FRANKLIN CITY HALL CHAMBERS  
9229 W. LOOMIS ROAD  
FRANKLIN, WISCONSIN

**PLAN COMMISSION MEETING AGENDA**  
**Thursday, August 8, 2024 at 5:00 P.M.**

**SHEET TITLE:**  
**SITE PLAN**

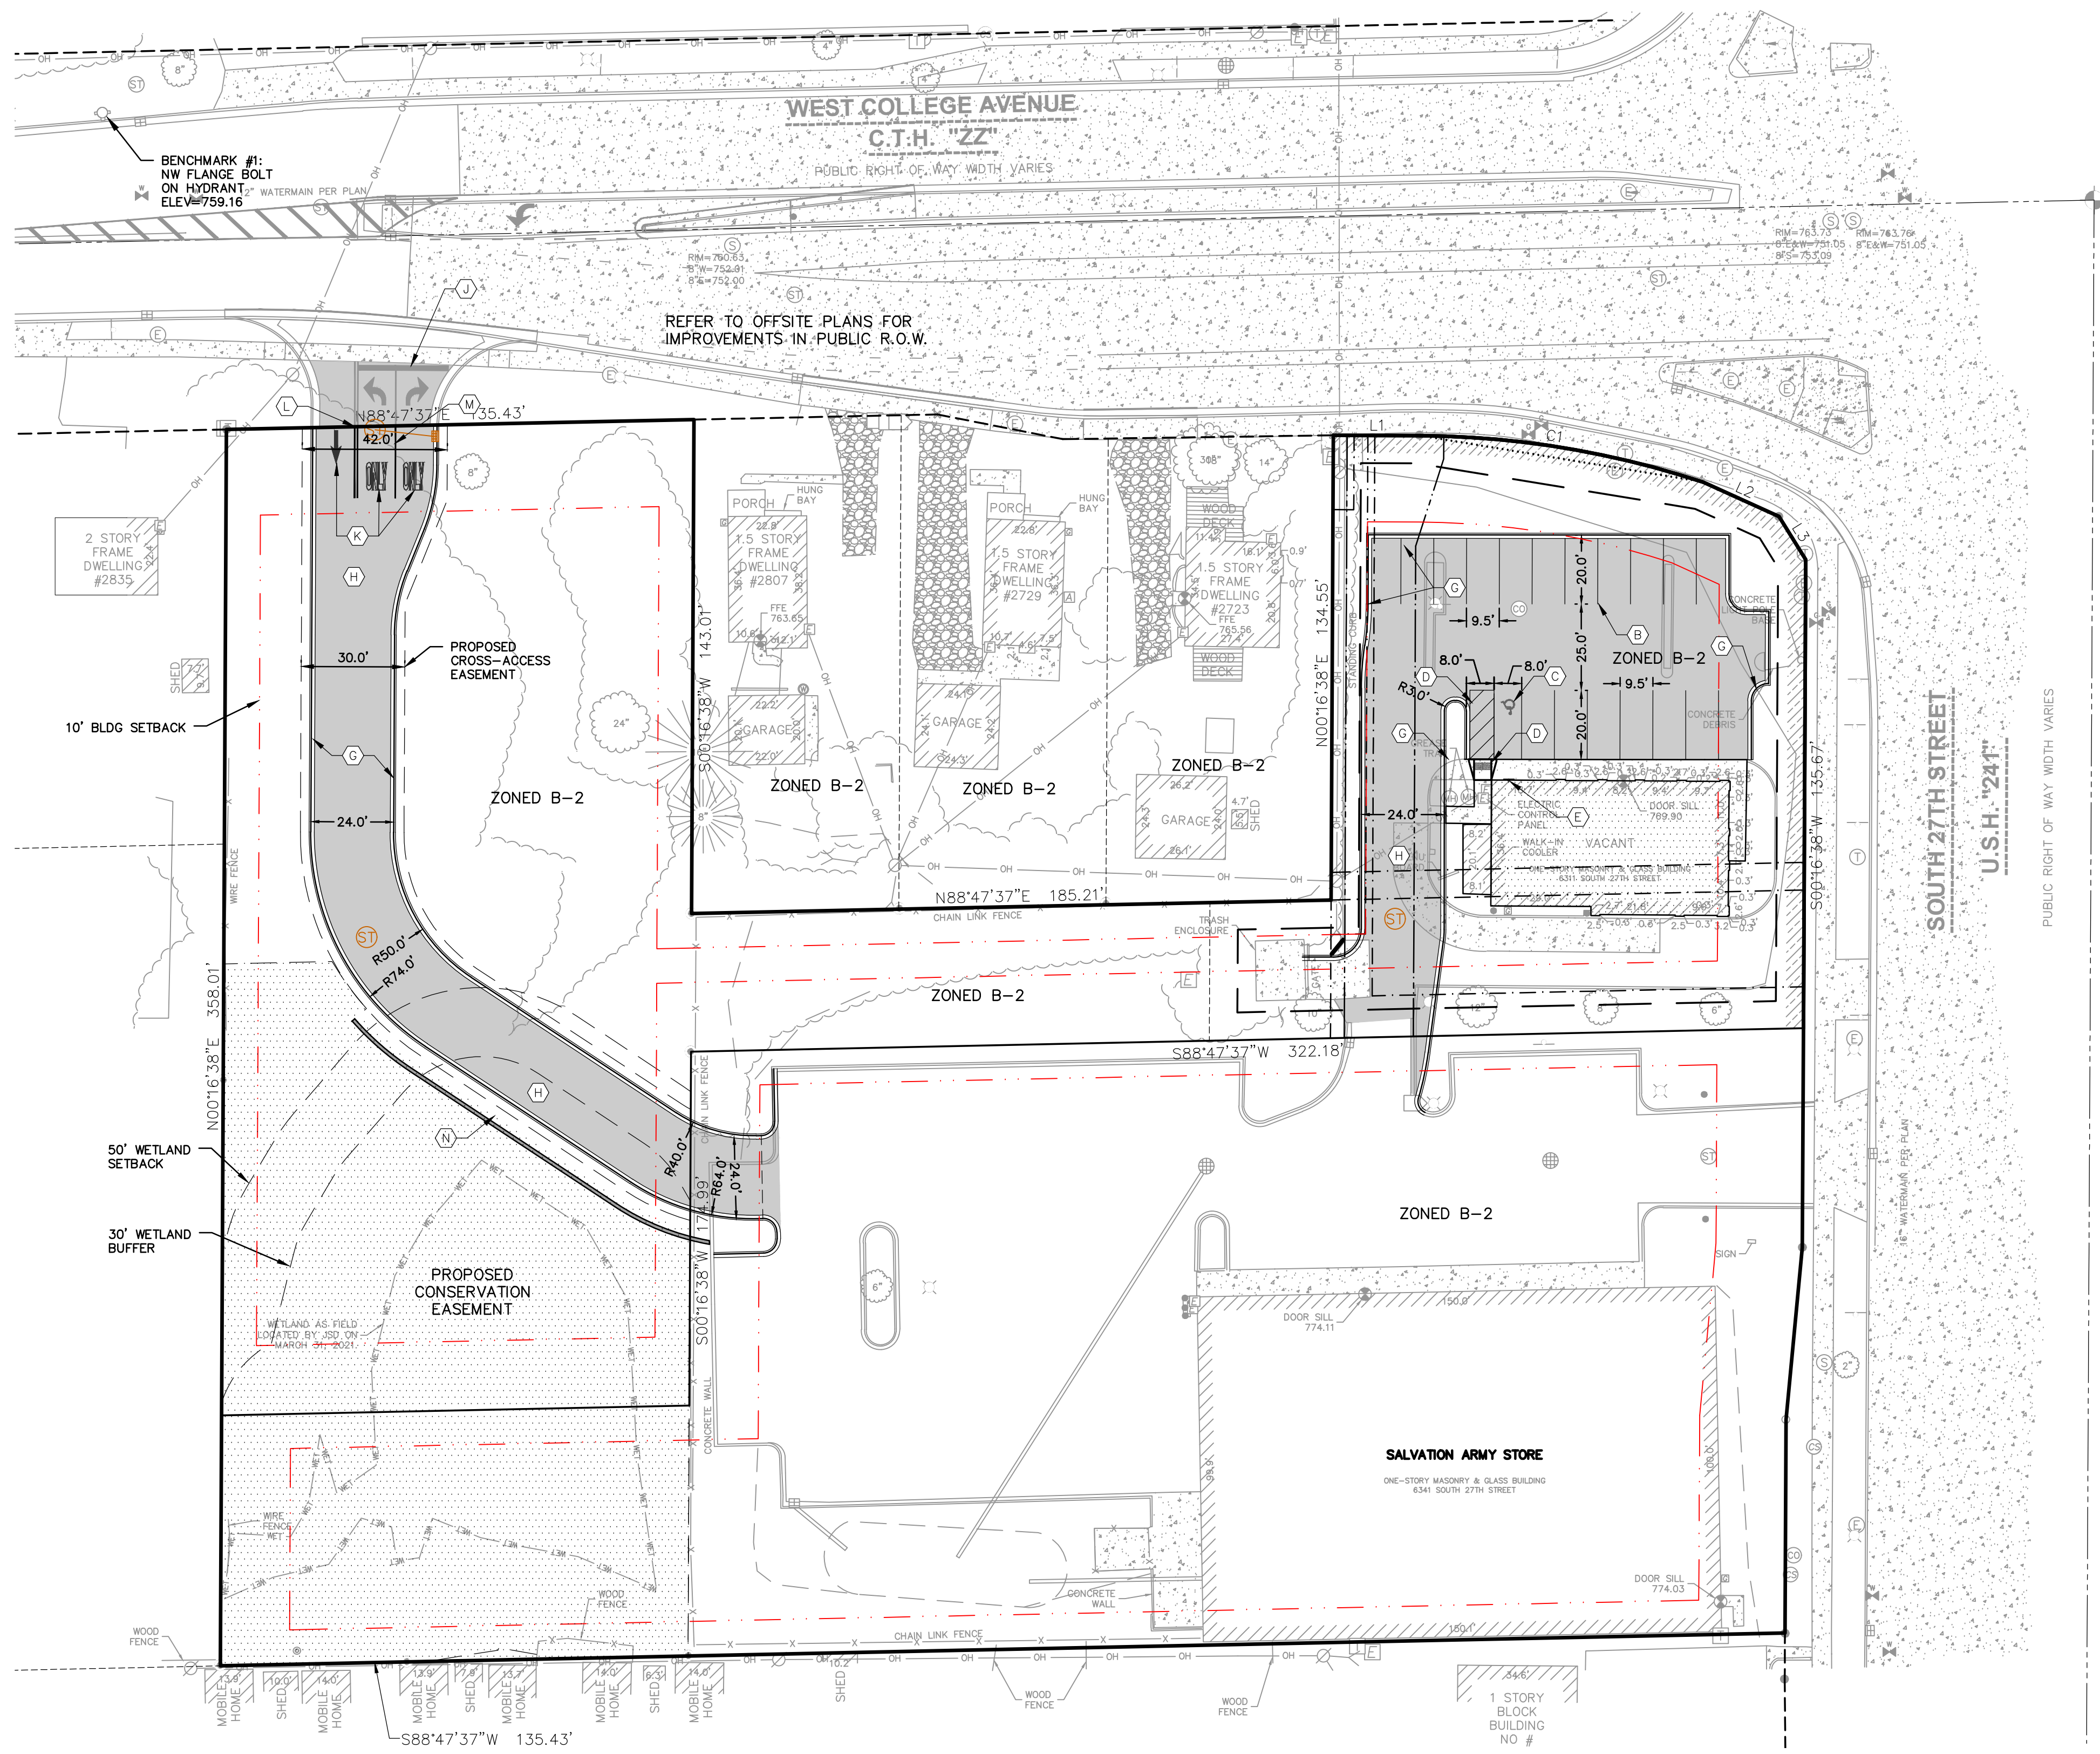
- a. Please show all B-2 District minimum building and natural resource setbacks on Sheet C2.0.

**Understood.**

SHEET NO.  
**C102**

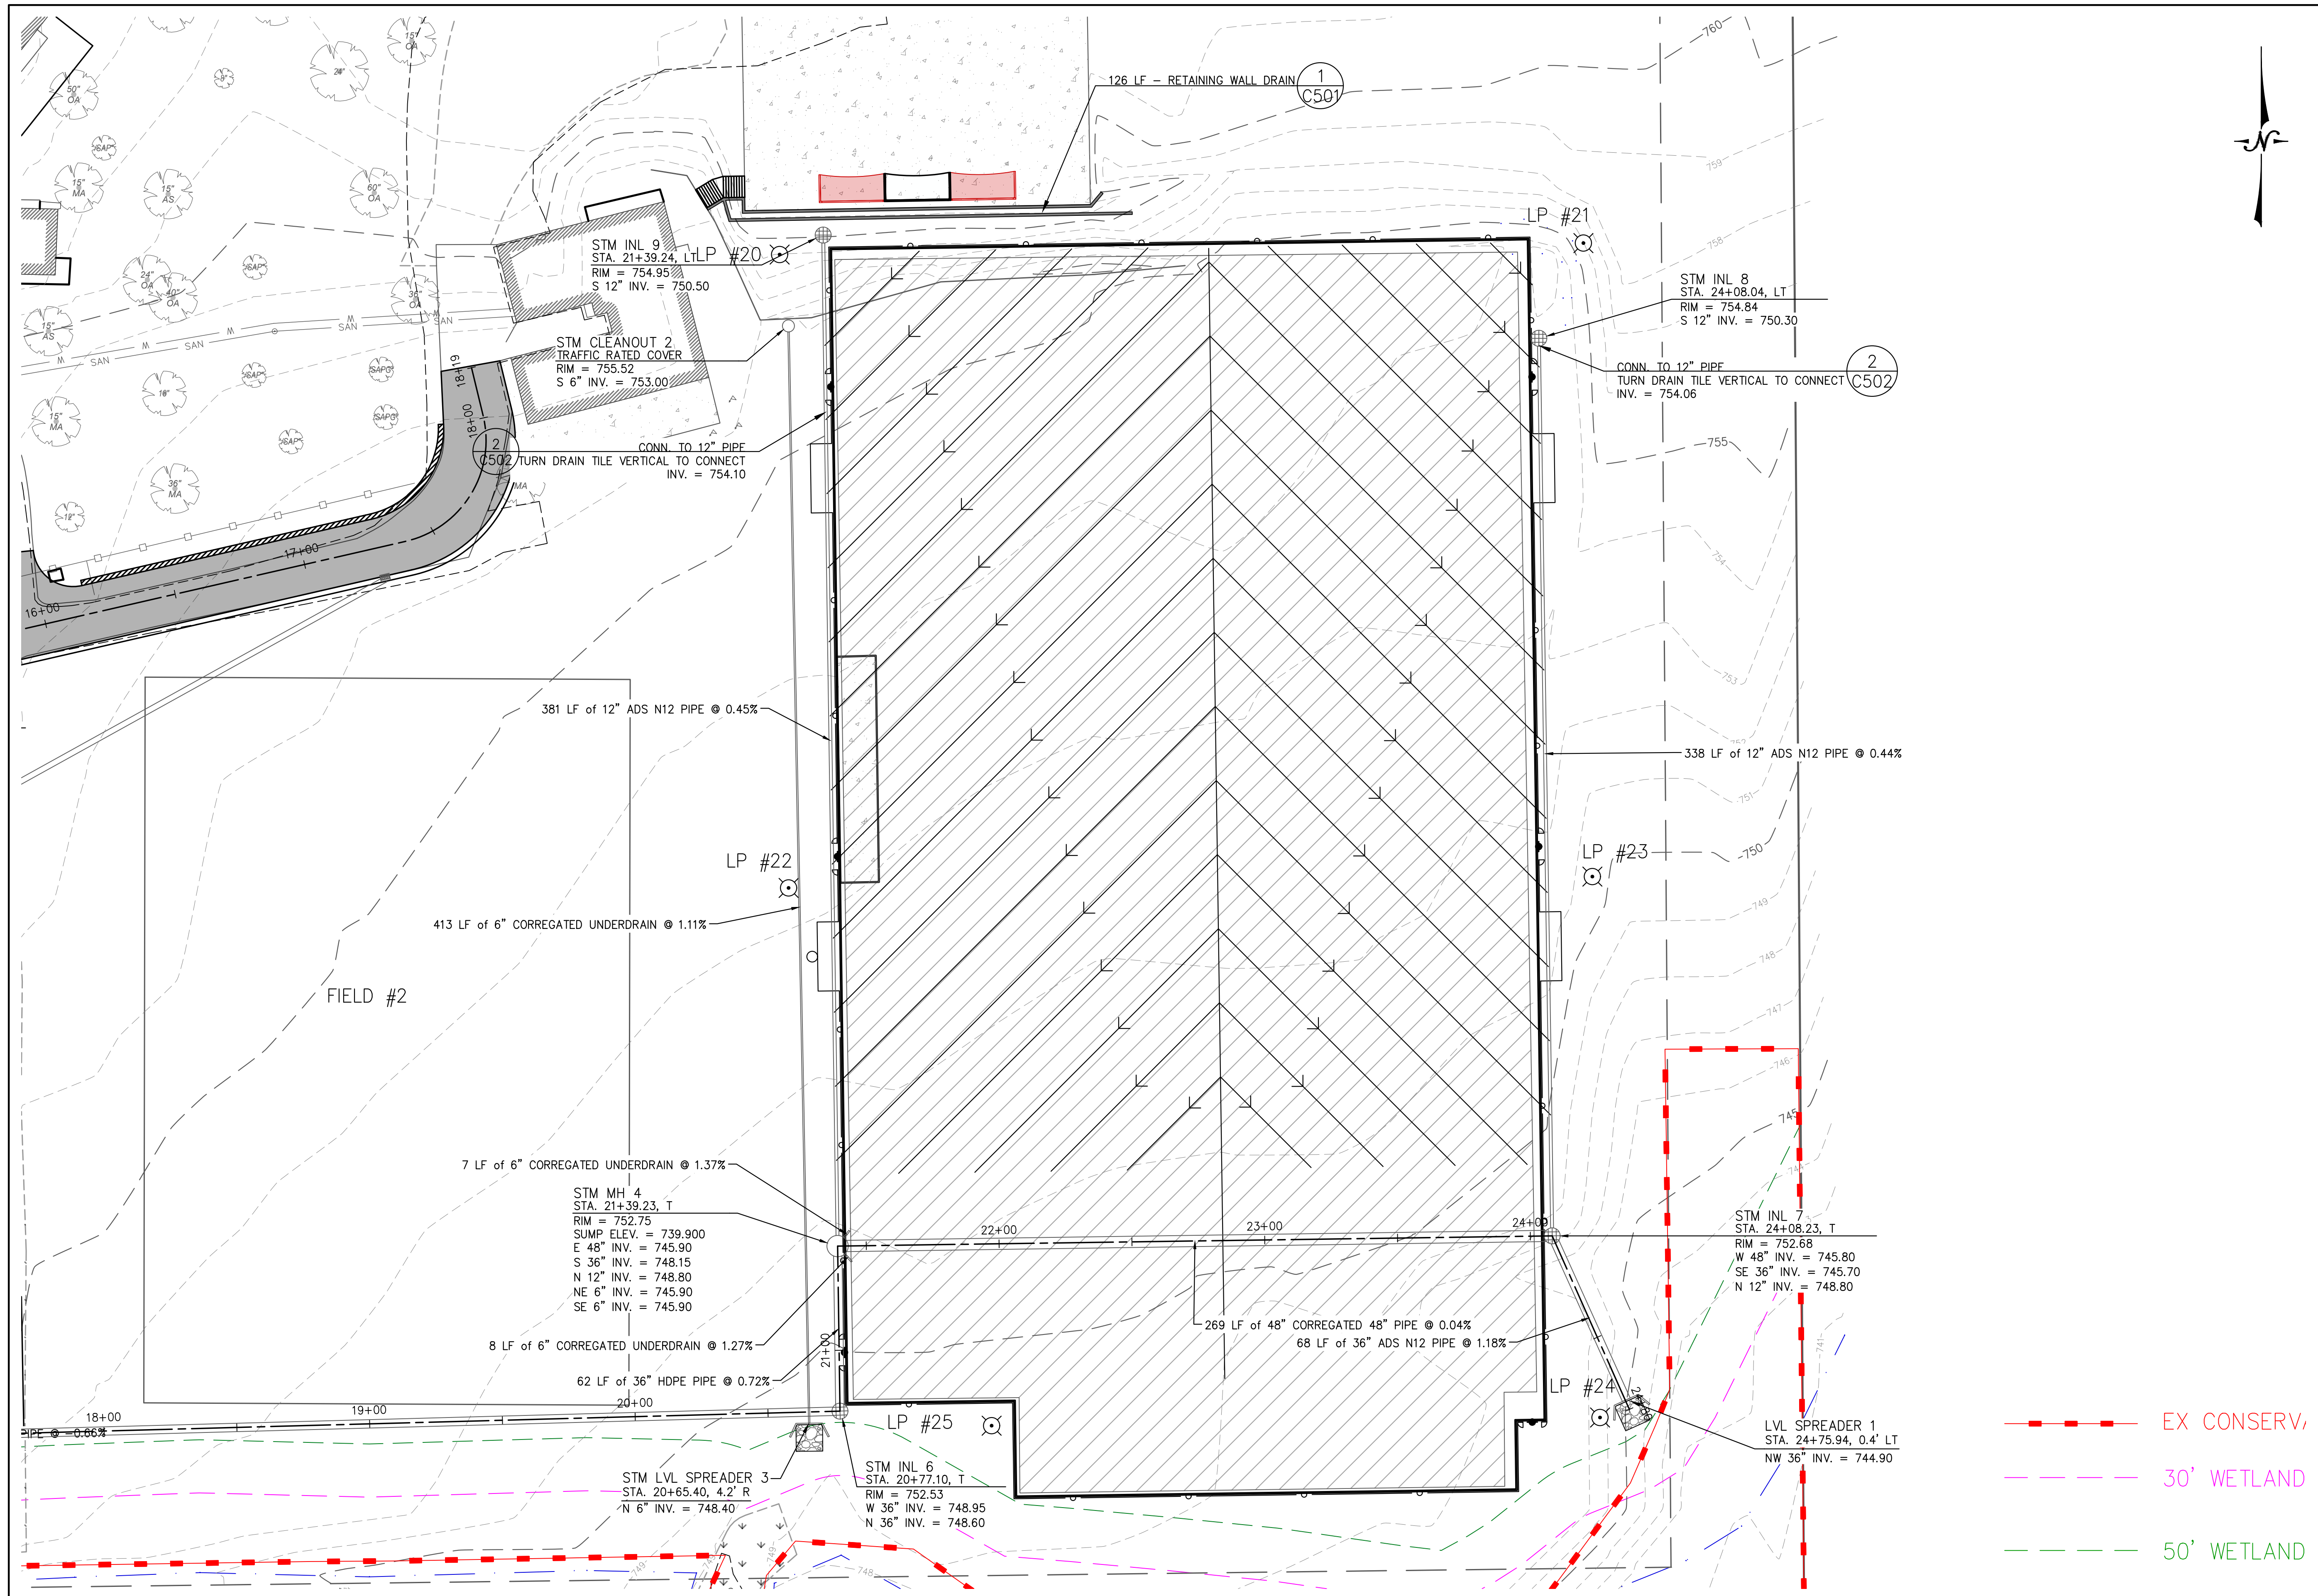
10. Is the pavilion parking being proposed as part of this project? The plans note that pavilion improvements are not part of this request; however, there is also a note that states "Proposed paved pavilion parking lot" on Sheet C102. Staff is just looking for confirmation.

**C108**

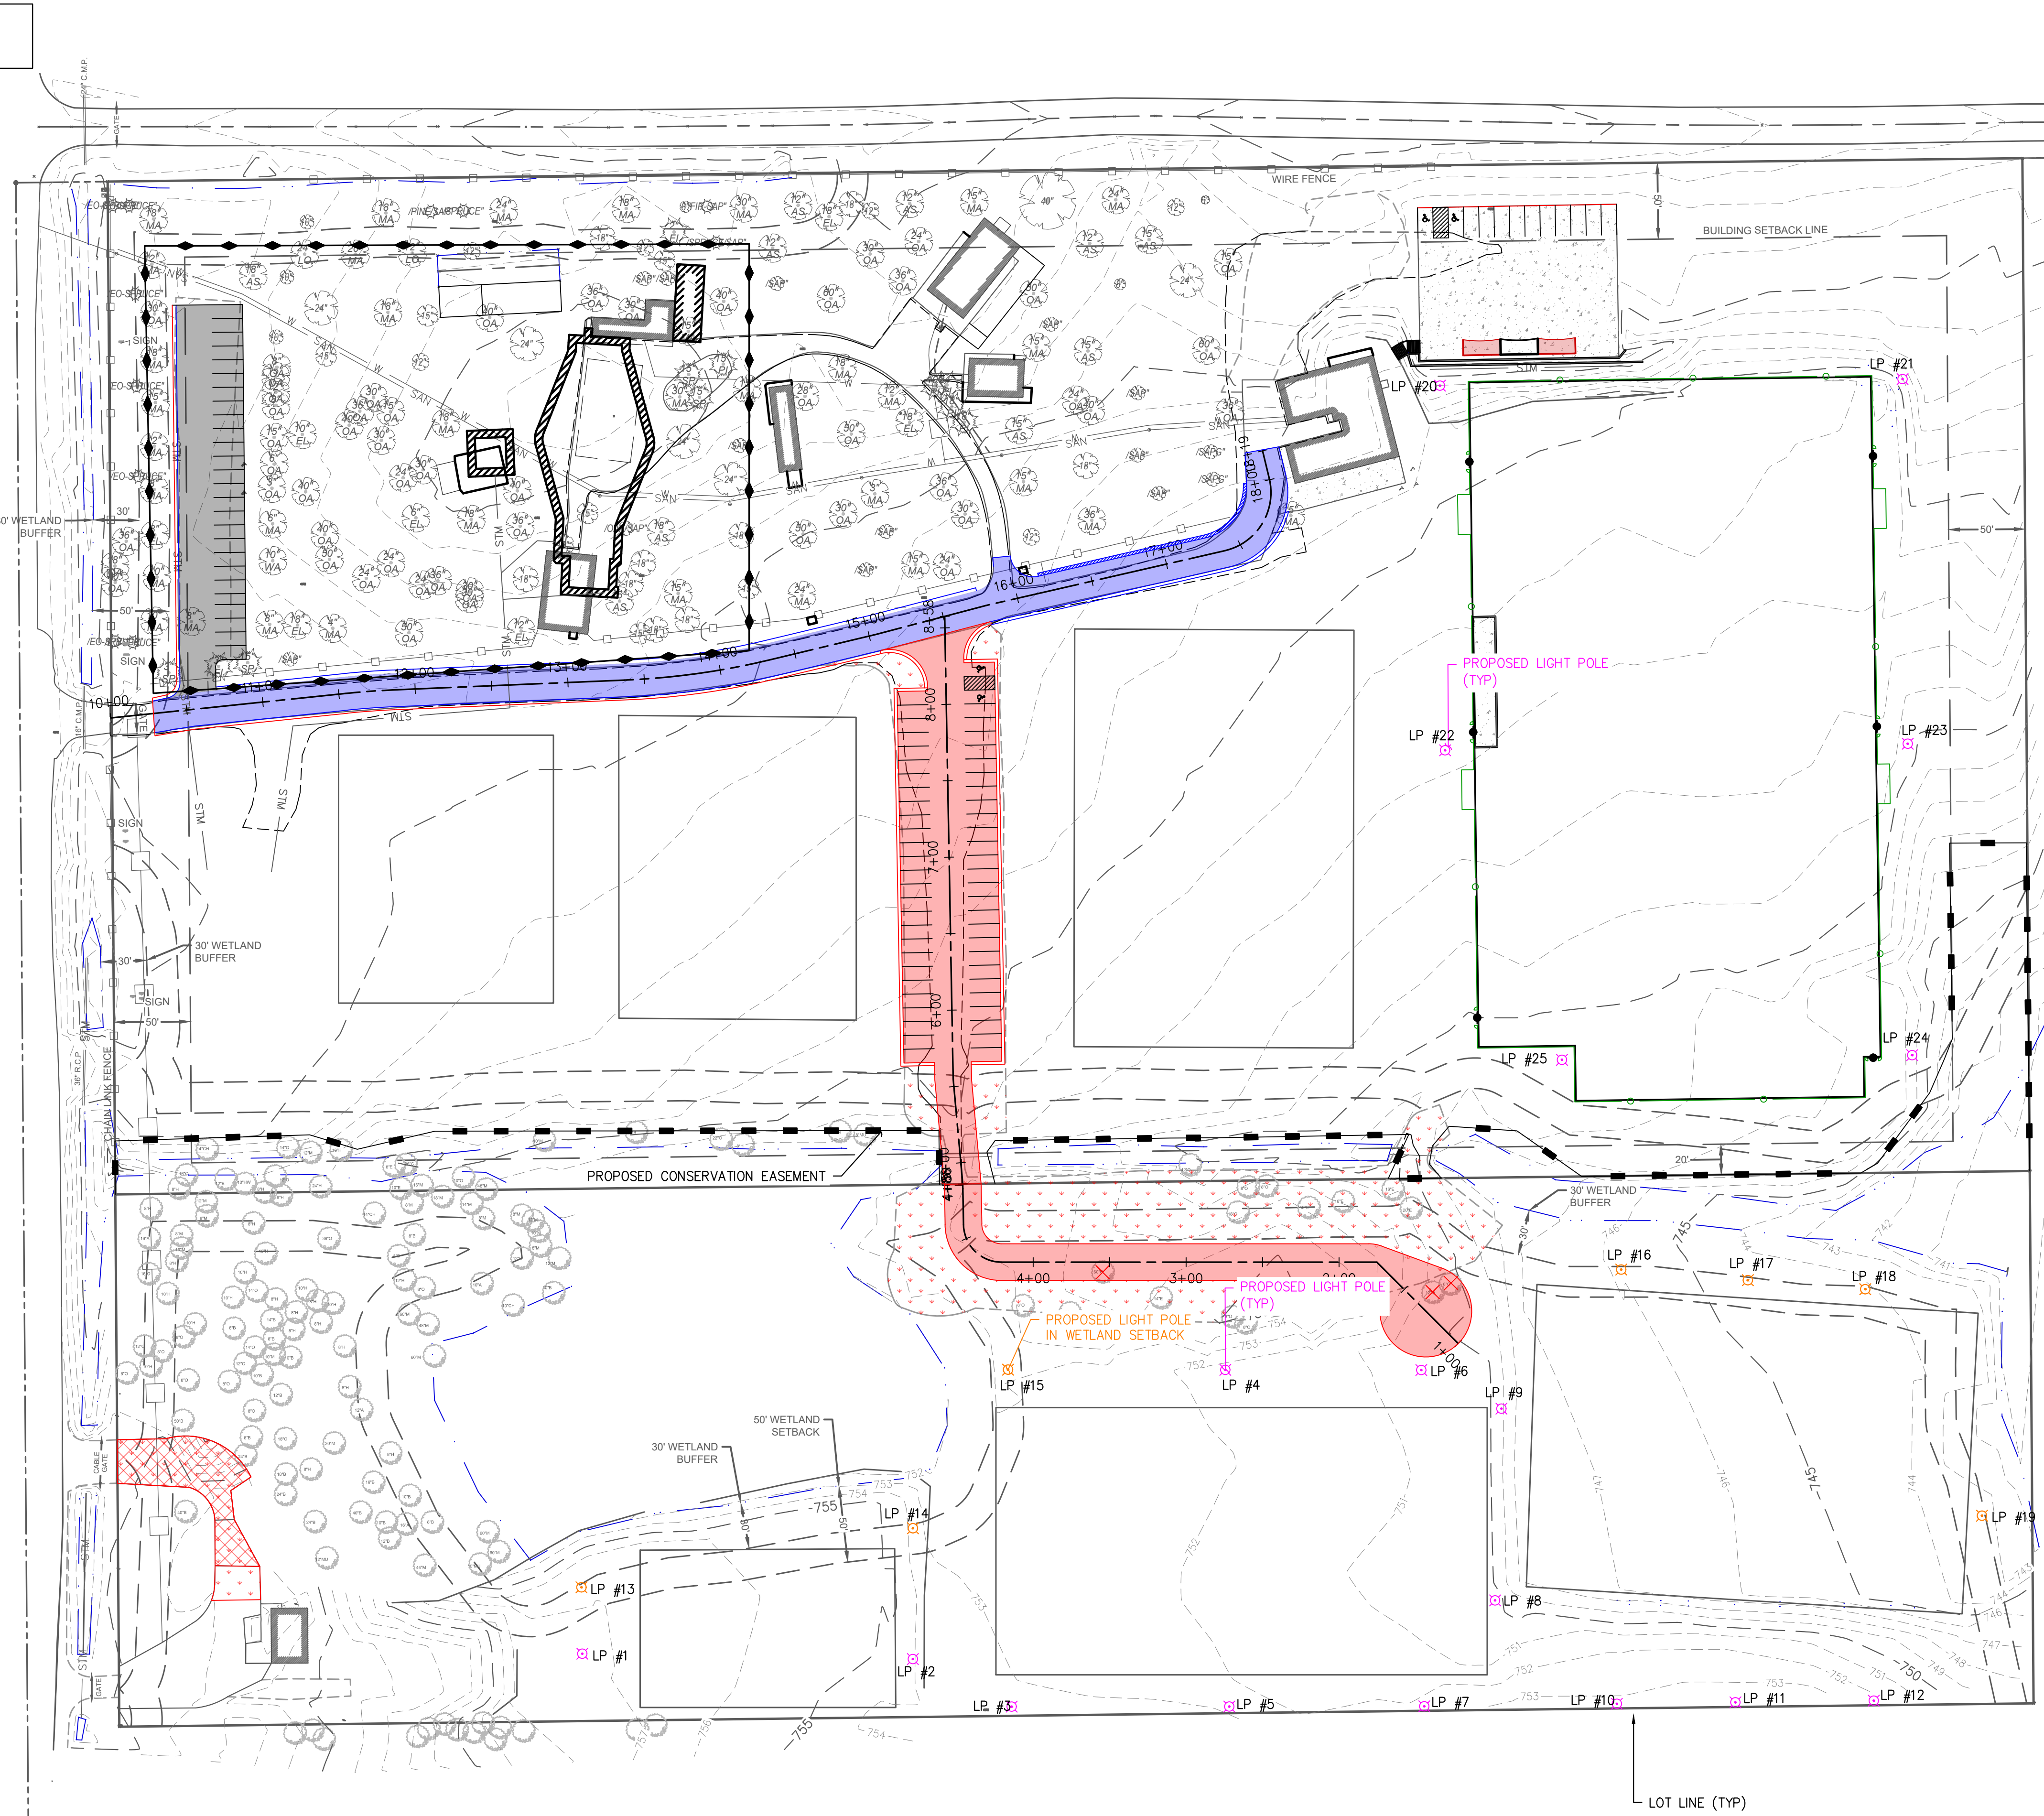
8. The Lighting Plan (Sheet C108) does not appear to show all proposed lights? A detailed lighting plan must be provided in conformance with Division 15-5.0400 of the UDO. The lighting plan submittal should include photometrics, fixture details, and peak height of all lighting.
